**CITY OF ANGLETON**  
**PLANNING AND ZONING COMMISSION SPECIAL MEETING**  
**AGENDA**  
**120 S. CHENANGO STREET, ANGLETON, TEXAS 77515**  
**MONDAY, JULY 06, 2026 AT 12:00 PM**

2. Discussion and possible action on the Preliminary Plat of Ashland Reserves Section 1 Preliminary Plat Review as submitted, and to consider updates to the Ashland Land Plan as it relates to this section located on the northeast corner of Ashland Blvd. and FM521.

Re: On-Going Services  
Ashland Reserves Section 1 Preliminary Plat Review – 1<sup>st</sup> Submittal Review  
Angleton, Texas  
HDR Job No. 10420700

# ASHLAND RESERVES SECTION 1

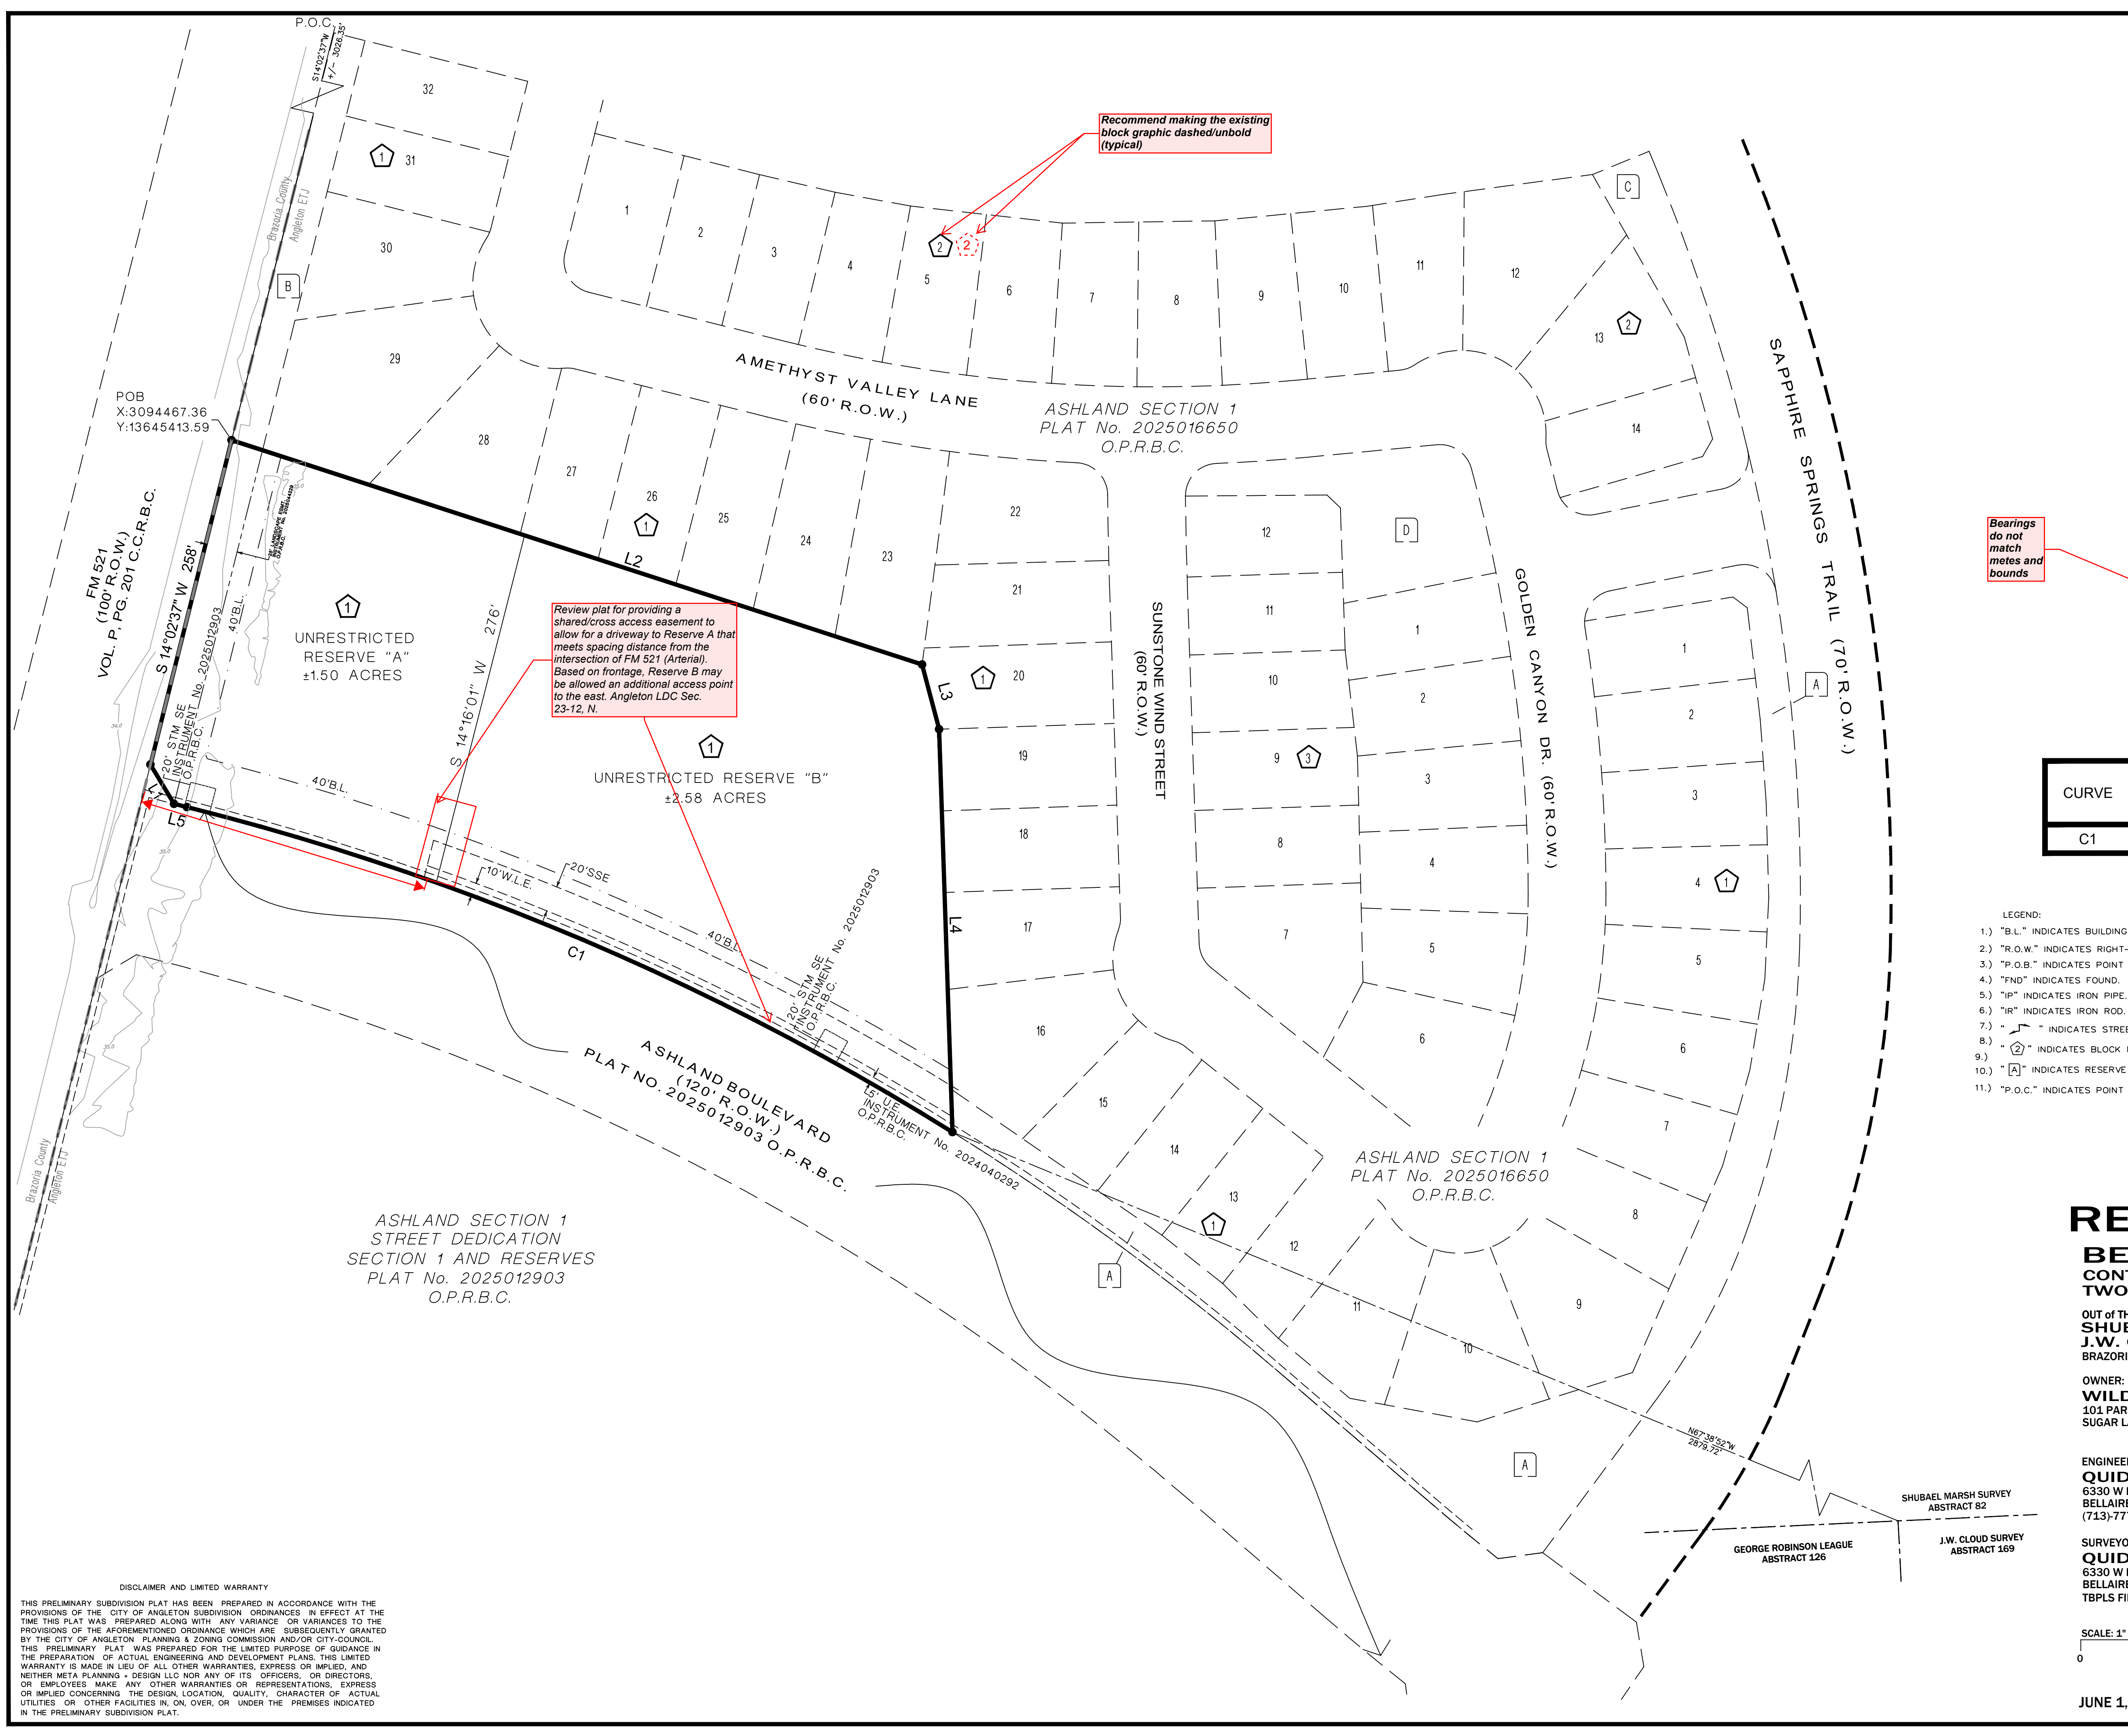
1. Review plat for providing a shared/cross access easement to allow for a driveway to Reserve A that meets spacing distance from the intersection of FM 521 (Arterial). Based on frontage, Reserve B may be allowed an additional access point to the east. Angleton LDC Sec. 23-12, N.
2. Bearings do not match metes and bounds.

3. For distance and lengths, provide decimals in the table to match metes and bounds.

4. Recommend making the existing block graphic dashed/unbold (typical).

1. Review plat for providing a shared/cross access easement to allow for a driveway to Reserve A that meets spacing distance from the intersection of FM 521 (Arterial). Based on frontage, Reserve B may be allowed an additional access point to the east. Angleton LDC Sec. 23-12, N.
2. Bearings do not match metes and bounds.
3. For distance and lengths, provide decimals in the table to match metes and bounds.
4. Recommend making the existing block graphic dashed/unbold (typical).

Bearings do not match metes and bounds

For distance and lengths, provide decimals in the table to match metes and bounds
